INTERNATIONAL STANDARD ISO 34-1:1994
TECHNICAL CORRIGENDUM 1

Rubber, vulcanized or thermoplastic — Determination of tear strength —

Trouser, angle and crescent test pieces

TECHNICAL CORRIGENDUM 1

Figure 2 — Angle test piece die

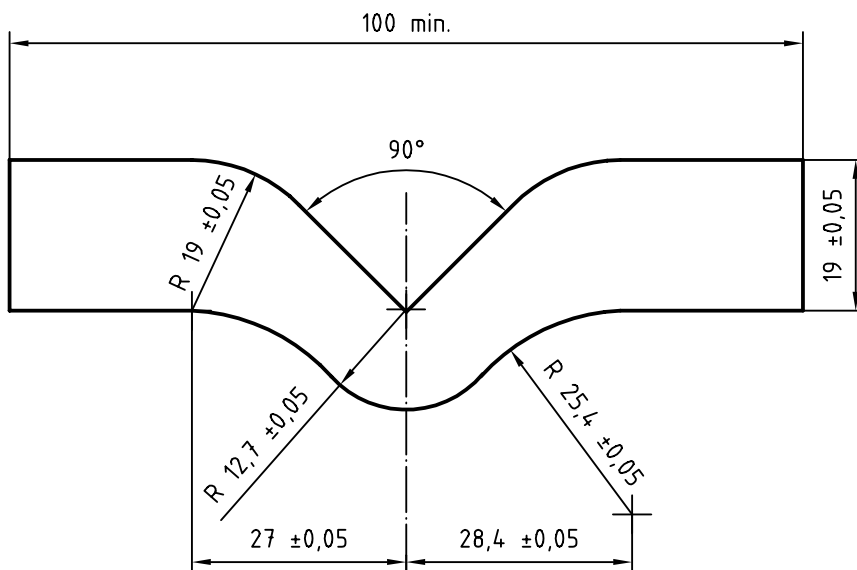
Figure 2

Replace the figure with the following, in which R 25 has been corrected to R 25,4 and 28 to 28,4 (see bottom right of figure).
